BAYSHORE ROOM PLANS
SYSTEM EFFICIENCY MODIFICATIONS
FOR CARILLON POINT
CARILLON POINT BUILDING 2000
4100 CARILLON POINT
KIRKLAND, WA 98033

Project P4730	Sheet M 1.0
Project Manager N. BAVINS	
Scale 1/8"=1'0"

PERMIT #	MNR12-02250
ADDRESS	4100 CARILLON PT
WORK CLASS	ALTERATION TO STRUCTURE OR SYSTEM
PROJECT	
OWNER	CARILLON PROPERTIES W BLVD
DT SUBMITTED	07/27/2012
DT APPROVED	8/27/12
APPROVED BY	Tom Rodfel

BAYSHORE ROOM – NEW HVAC PLAN

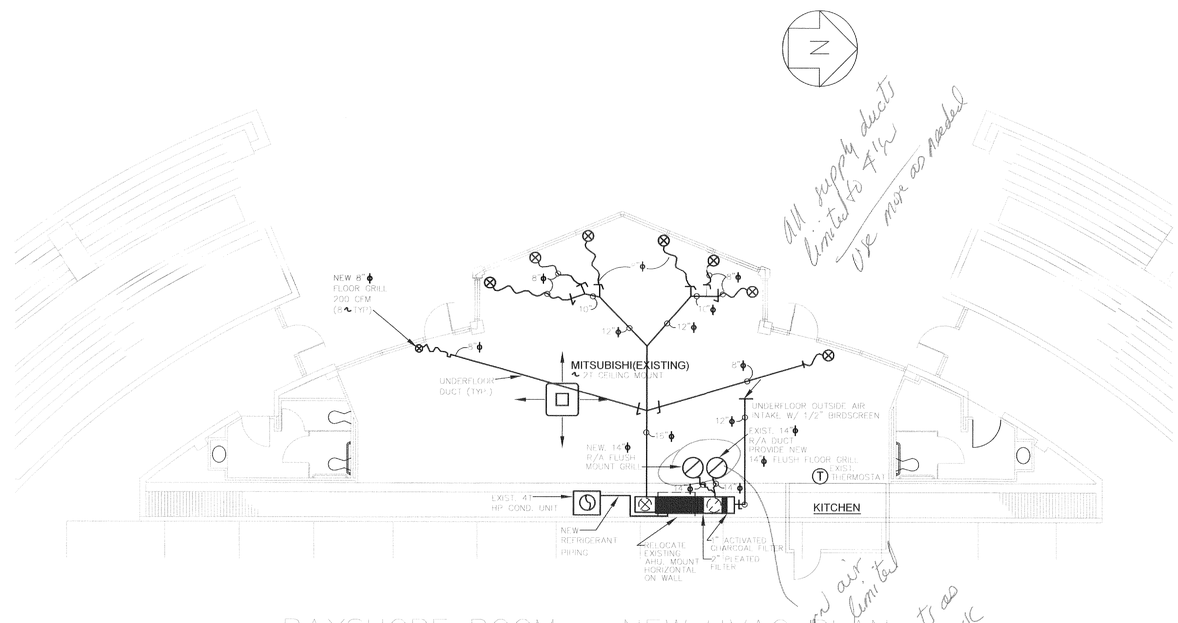
All supply ducts limited to 4"ø
Use more as Needed

This system must shut down if fire alarm is activated

Return air ducts are limited to 8"ø
Use more ducts as needed a cost back of room

Economizer req.
